# NORTHWEST AIRPORT WAY MASTER PLAN

## FINAL ENVIRONMENTAL IMPACT REPORT

SCH No.: 2010022024

**FINAL**  
**Environmental Impact Report**  
**Northwest Airport Way Master Plan**  
**City of Manteca, San Joaquin County, California**

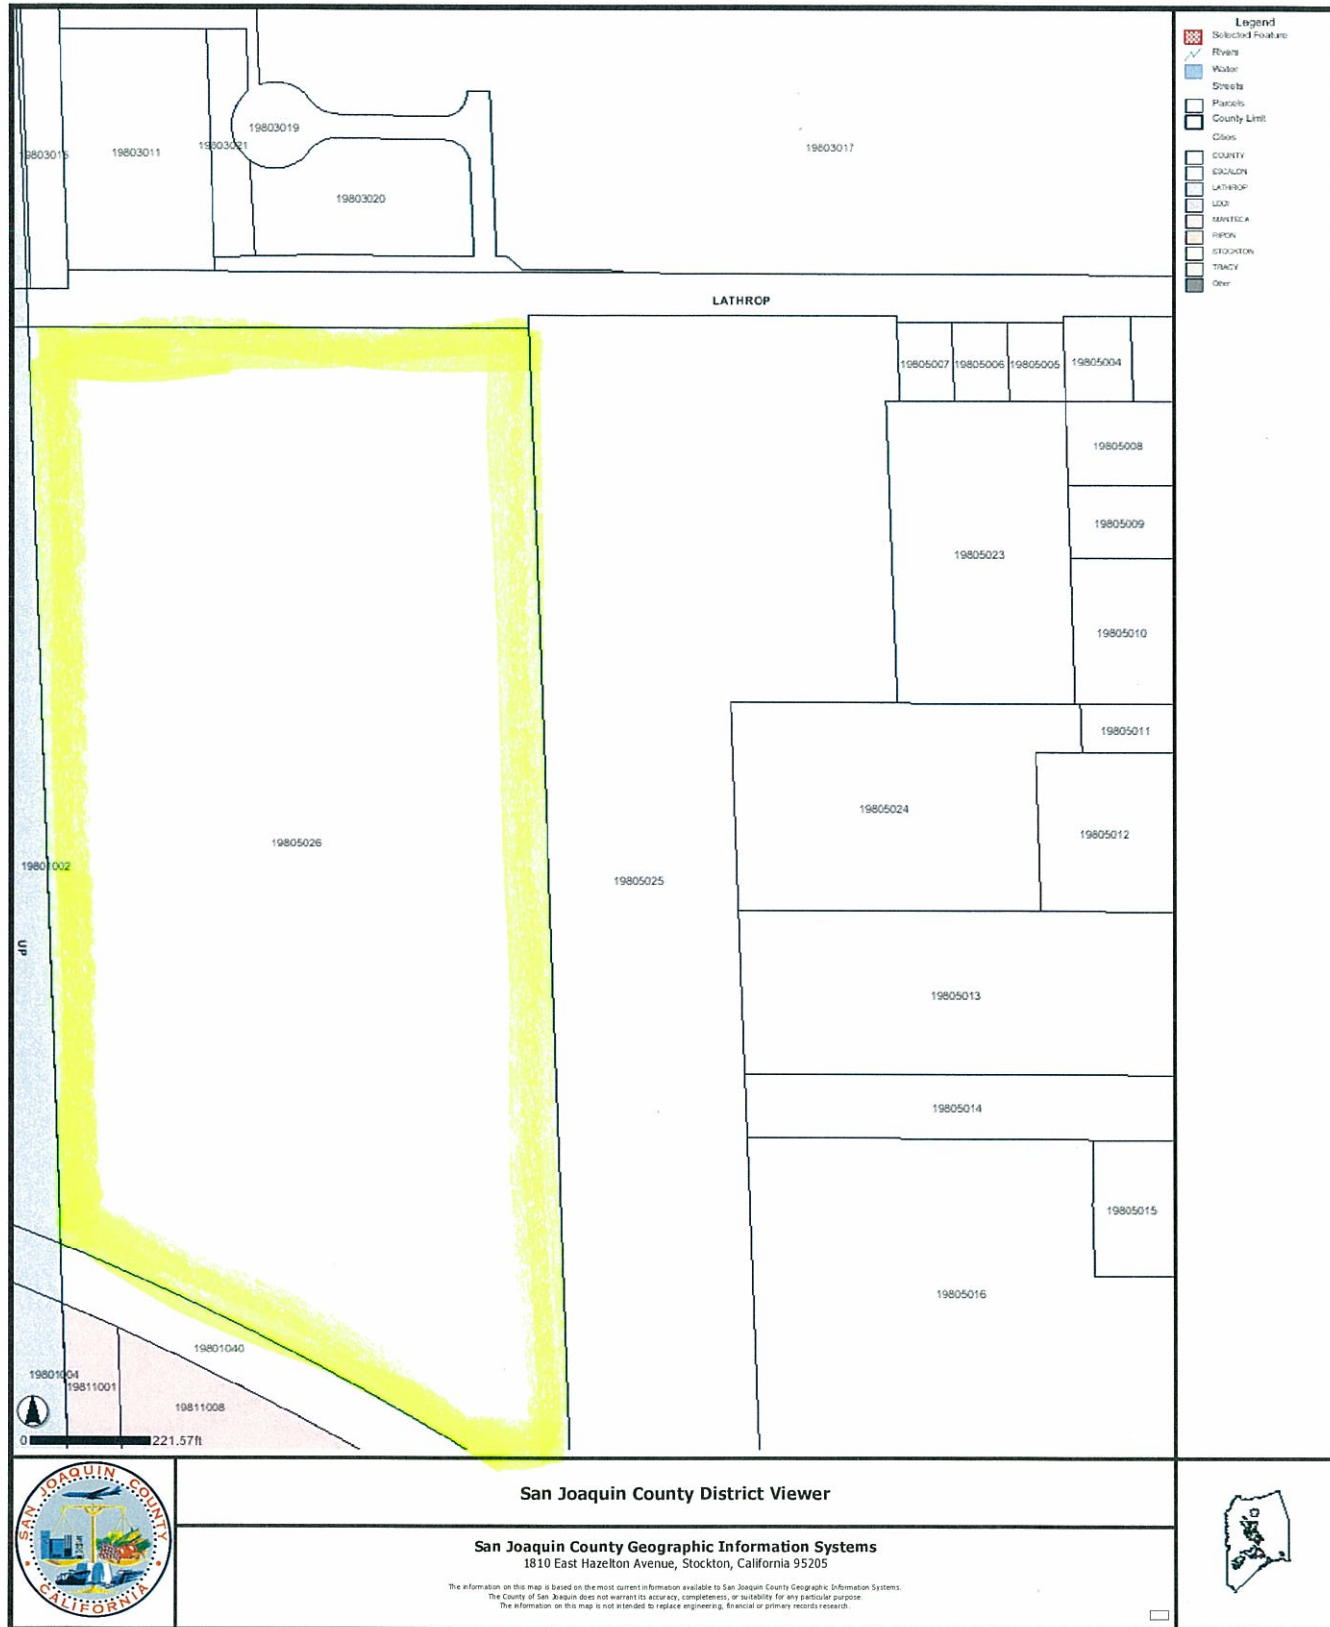
4. According to City of Manteca public works, the design capacity of the existing sewer pump station on Airport Way includes the future development proposed for the Livermore Acres property. Does that determination change with the development of the master plan area?

CANTU-5
